N9912A-09A

# Modification Recommended Service Note

## N9912A – 4/6 GHz FieldFox RF analyzer

Affects: N9912A and N9923A

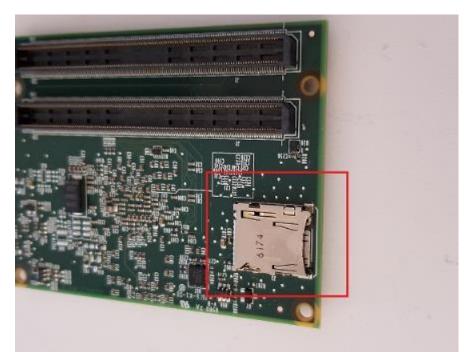
c. Using an Exacto Knife remove the Epoxy bridge holding the SD Card into the SD card socket.

d. Use caution to not damage the socket or other parts of the CPU board.

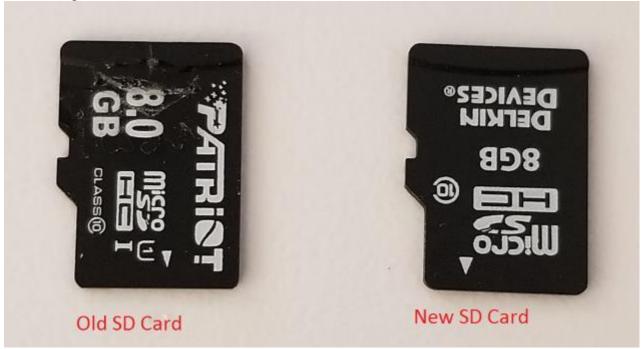
e. To remove the SD card, press the SD card slightly in towards the socket, it will click and then release to remove the SD card. Remove any extra epoxy that may be left.

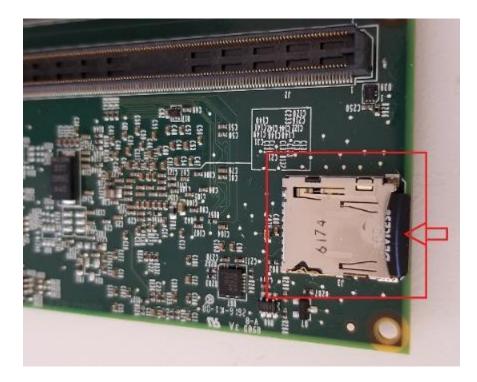
f. Here are the Old and New SD cards. The old SD card (Patriot) is on the left. The New (Delkin) is on the right.

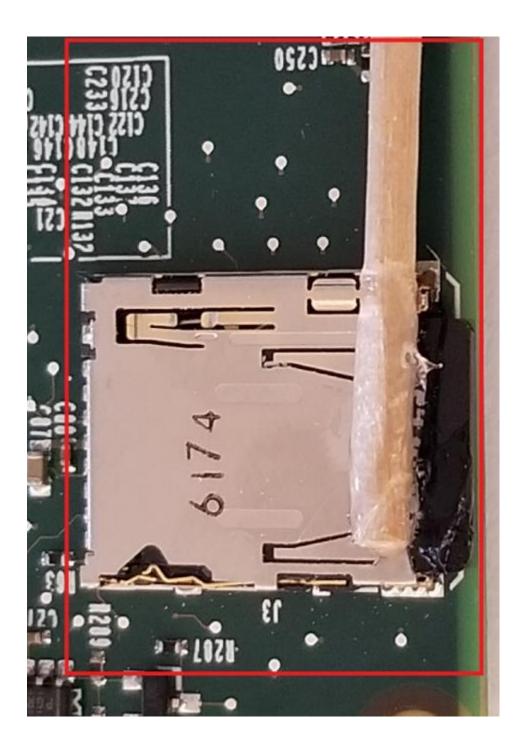
g. Insert the NEW SD card into the SD card socket and press it in until you hear a click, then release. The SD card is now locked in the socket.

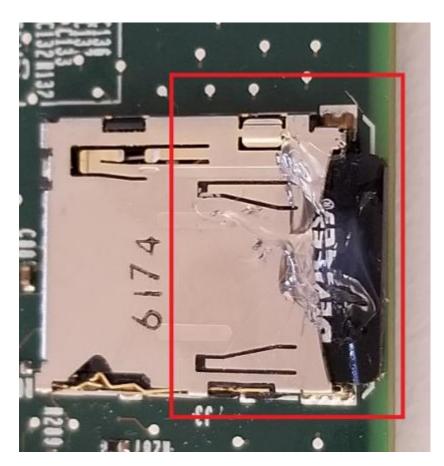
h. It is now necessary to add a small amount of RTV (part number 0470-0450) to bridge the SD card to the SD card socket. Using a wooden Q-Tip place a small amount of RTV on both the SD card and the socket.
